Proposal Request

PROJECT: *(name and address)*
AWSOM
Bentonville, Arkansas

PROPOSAL REQUEST 105

RFI #553 Data Room Equipment Racks

THIS PAGE IS BEST
 VIEWED IN COLOR
TN401

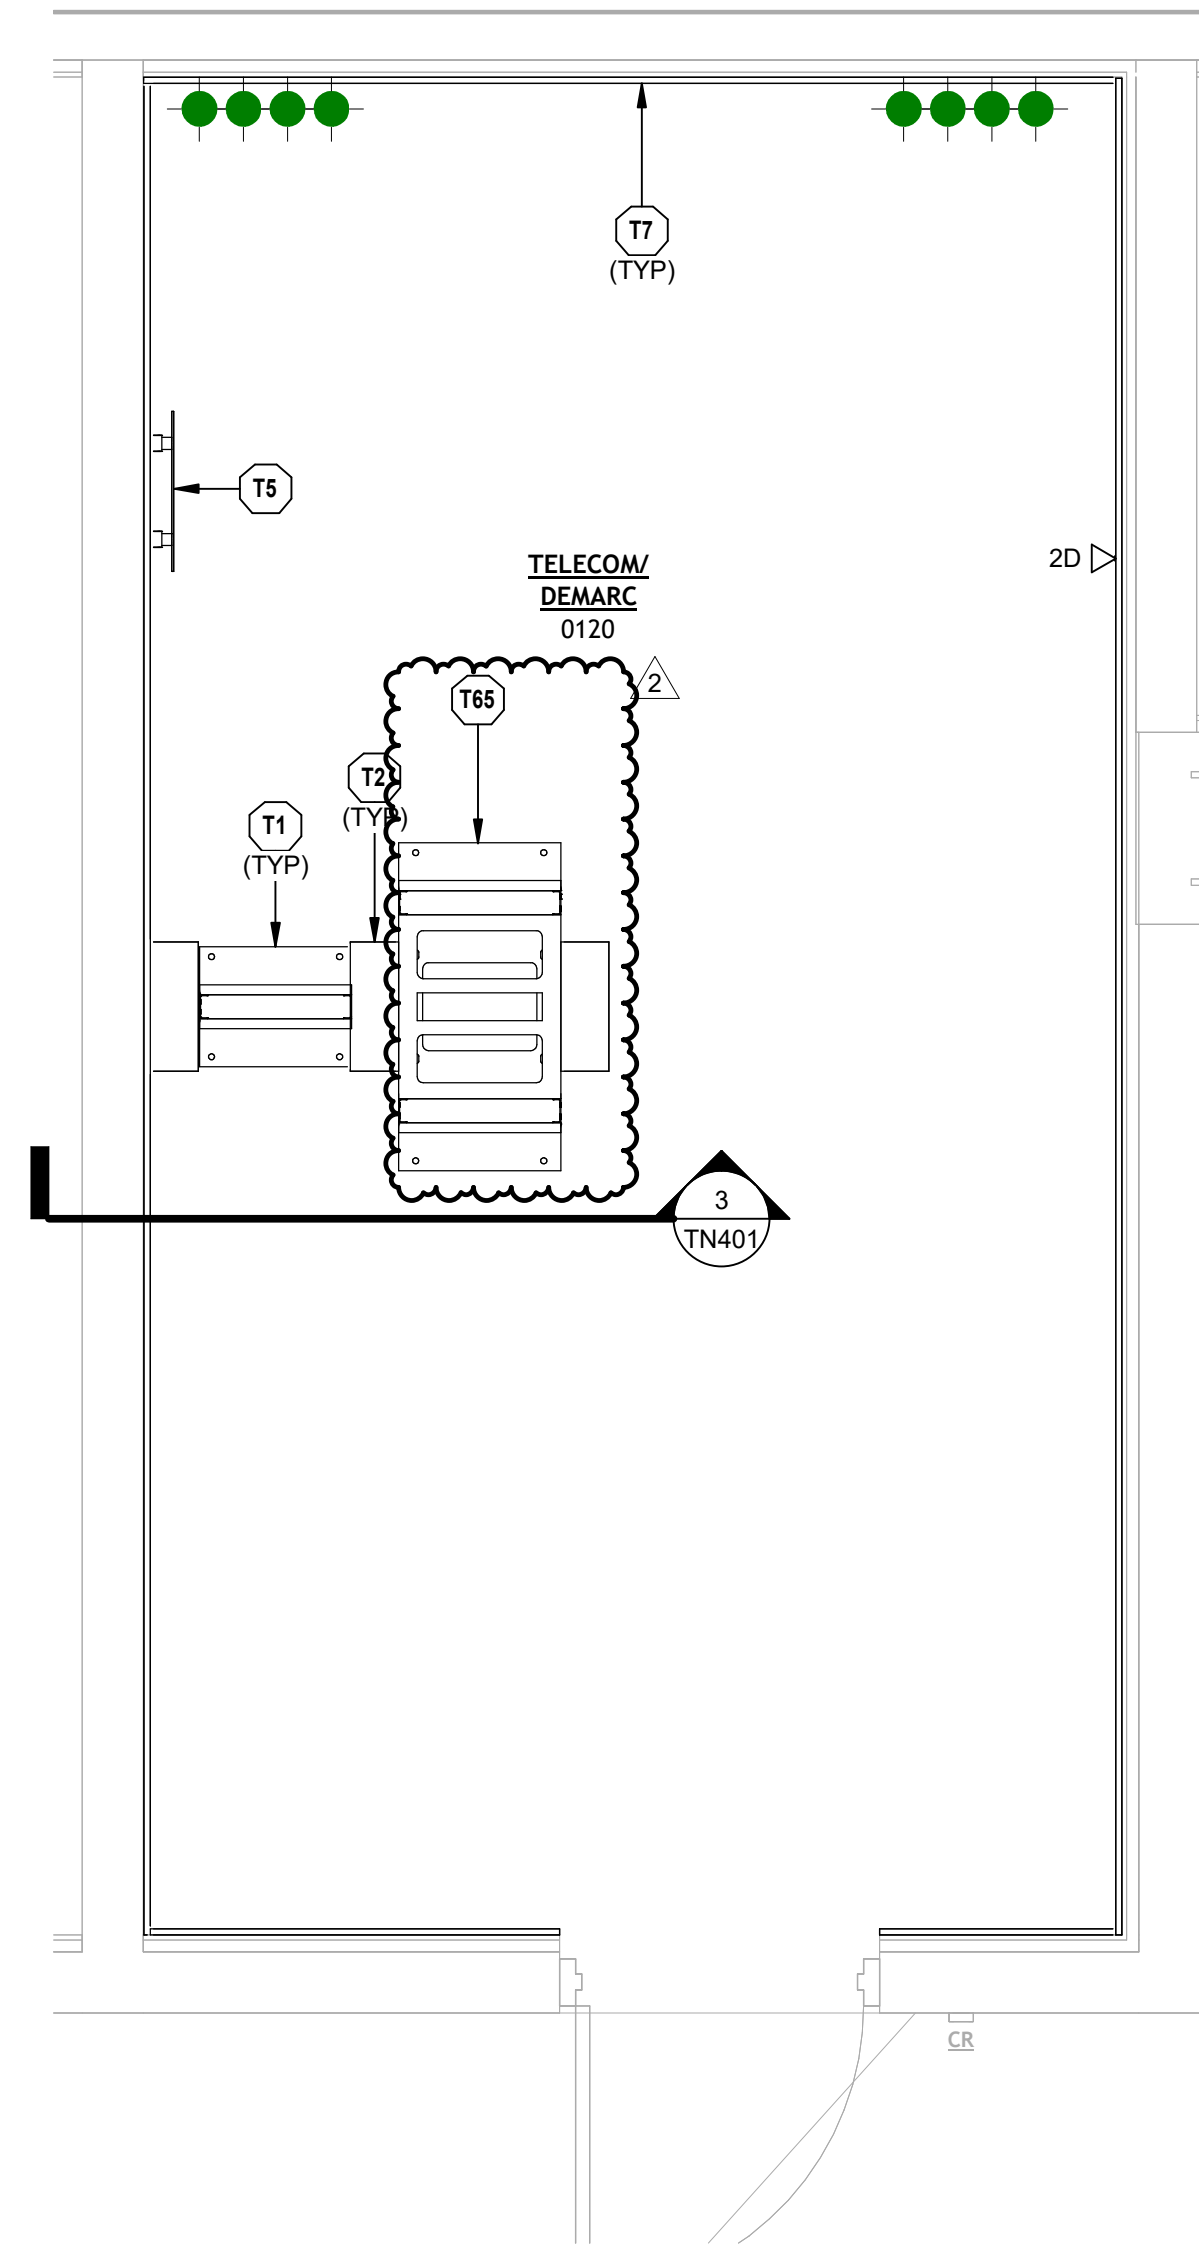
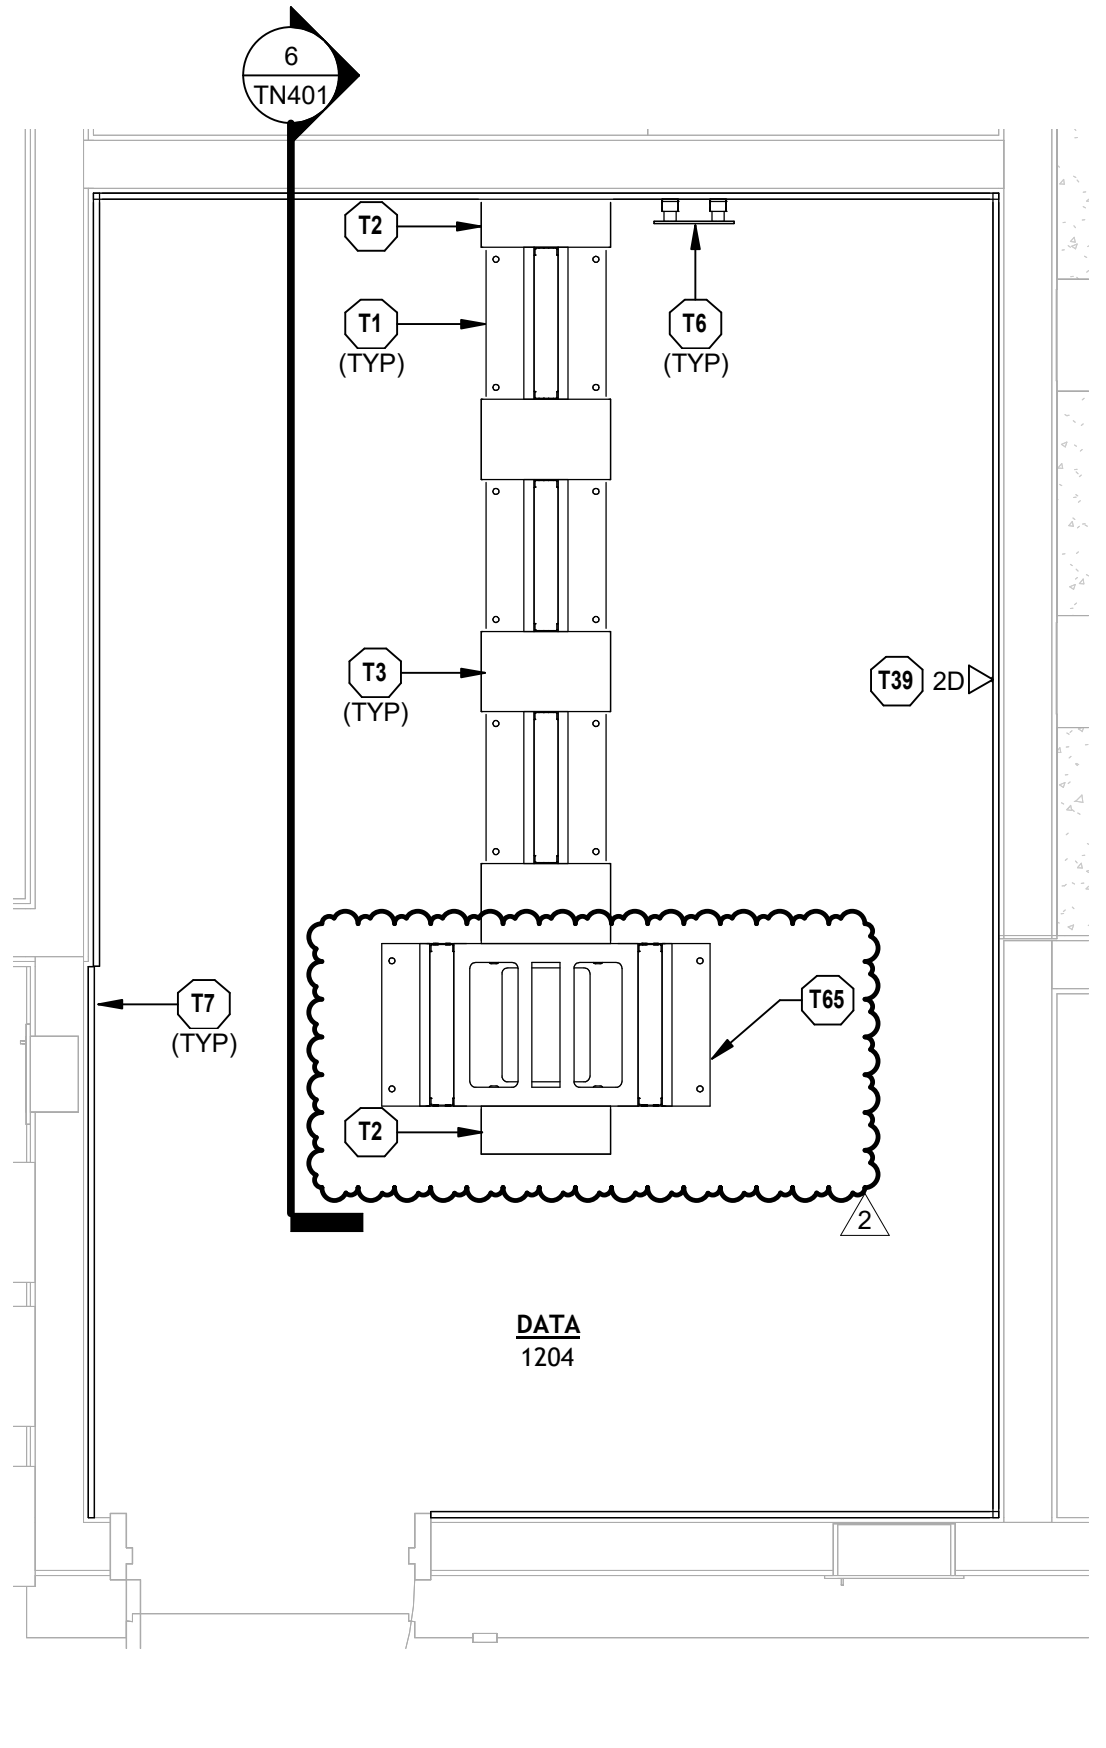
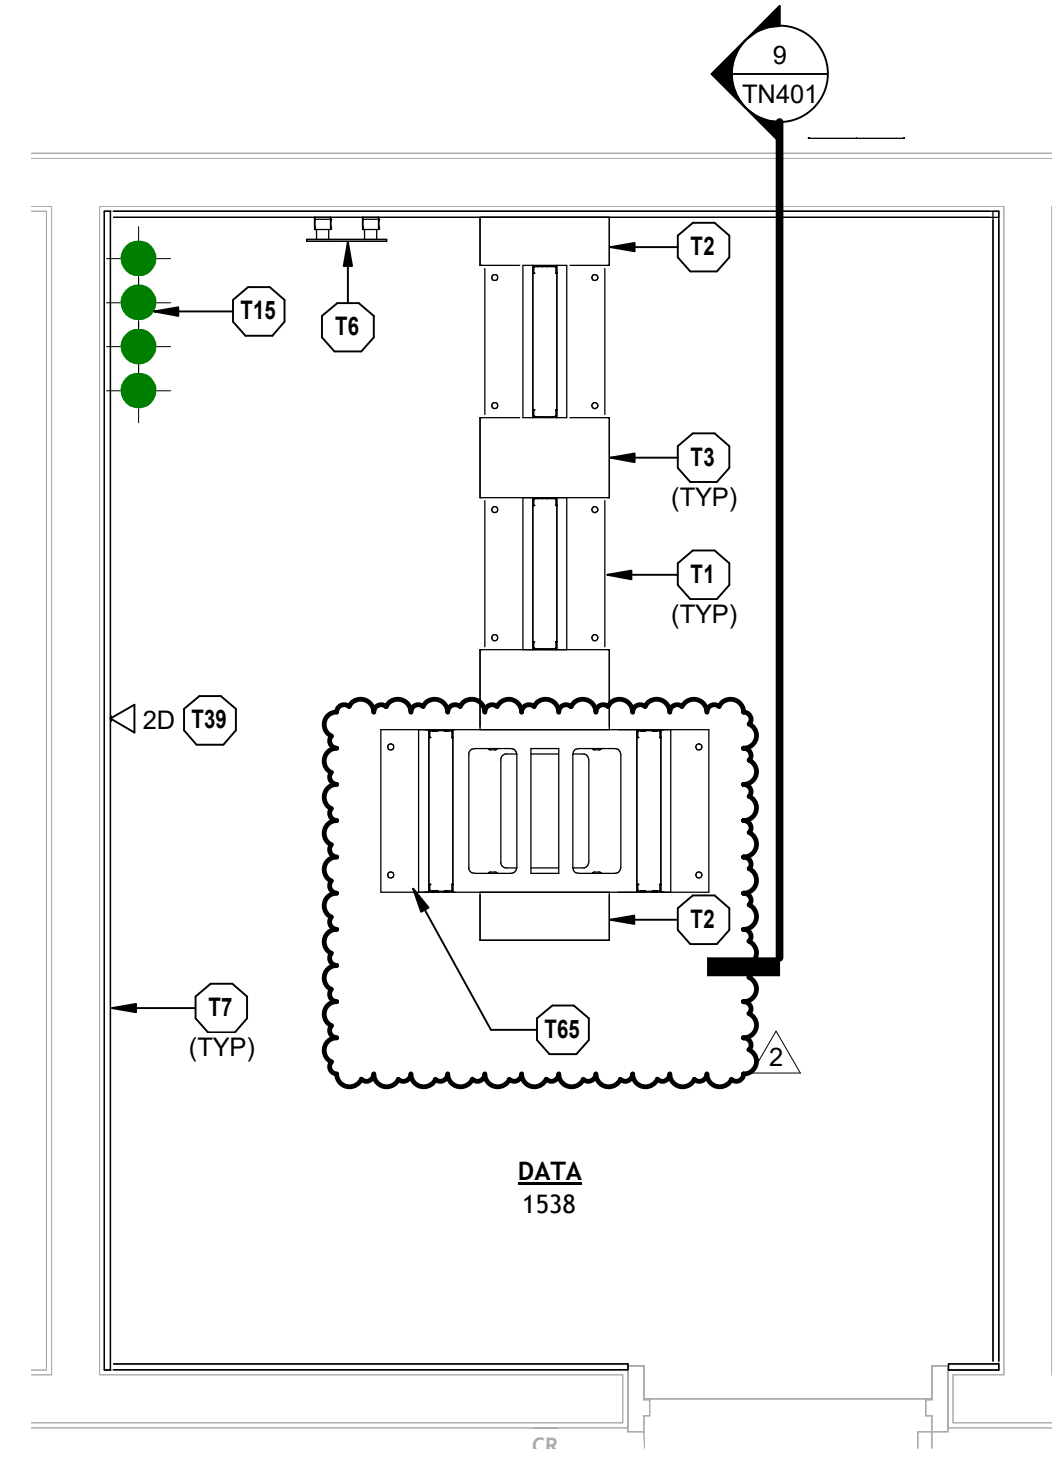
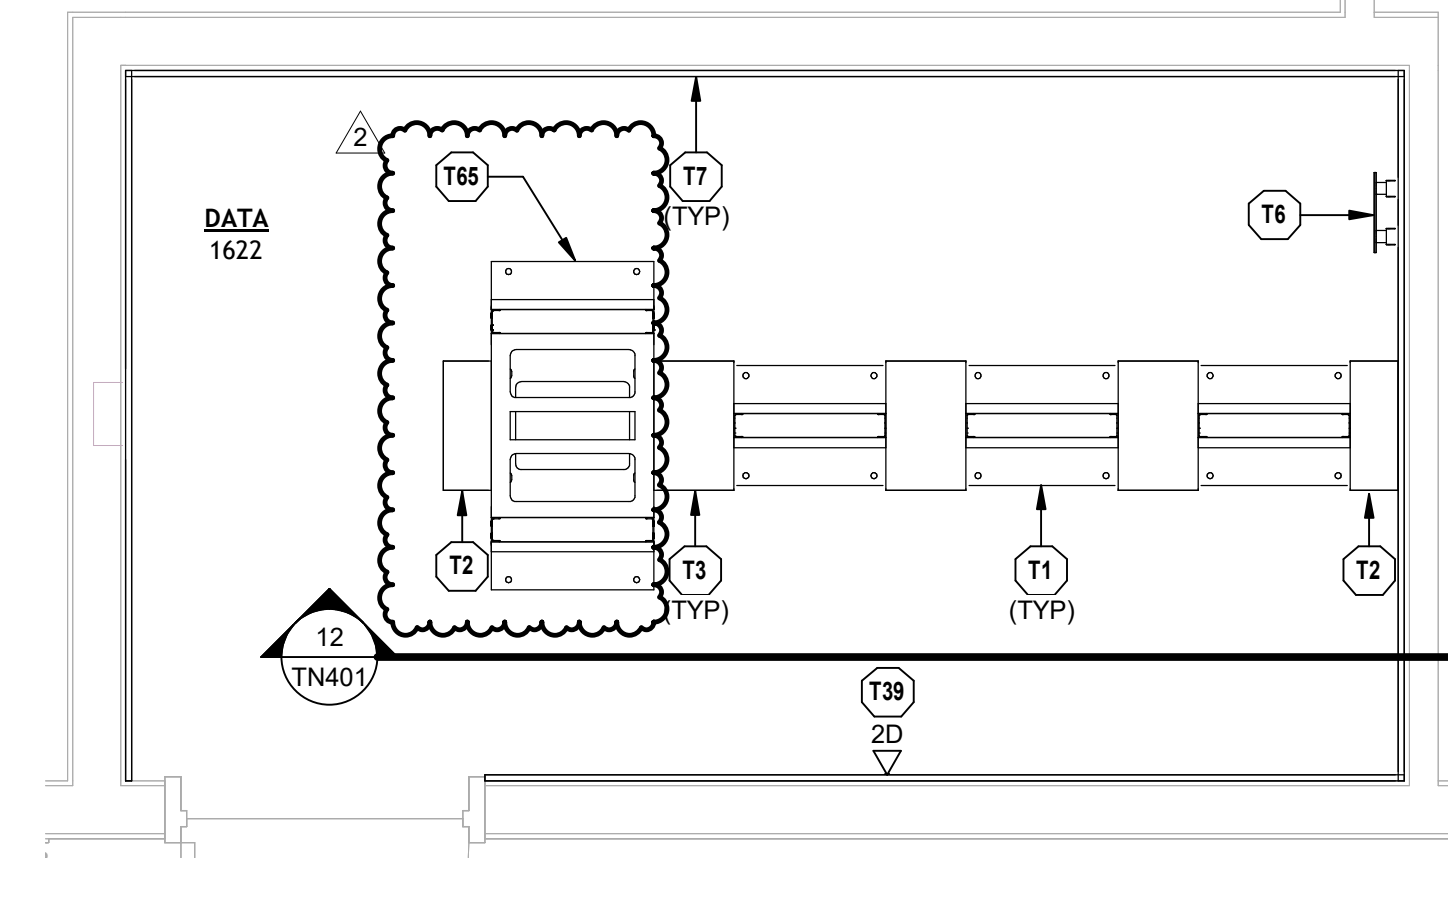
- a) Revised Sheet **TN401**
 - Added keynote T65.
 - Changed (1) 2-post rack in each telecom room to a 4-post rack.
(1) Applies to Rooms 0120, 1204, 1538, and 1622.
- b) Revised Sheet **TN402**
 - Added keynote T65.
 - Changed (1) 2-post rack in each telecom room to a 4-post rack.
(1) Applies to Rooms 2219, 2502, and 3102.
 - Detail 8 – Added keynote T11 pointing to already present conduit sleeves.
- c) Revised Sheet **TN403**
 - Added keynote T65.
 - Changed (1) 2-post rack in each telecom room to a 4-post rack.
(1) Applies to Rooms 3316, 3504, and 4104.
 - Detail 2 – Added keynote T11 pointing to already present conduit sleeves.
 - Detail 8 – Added keynote T11 pointing to already present conduit sleeves.

- T65 PROVIDE FOUR-POST FLOOR RACK. SEE DIVISION 27 SPECIFICATIONS FOR ADDITIONAL INFORMATION.
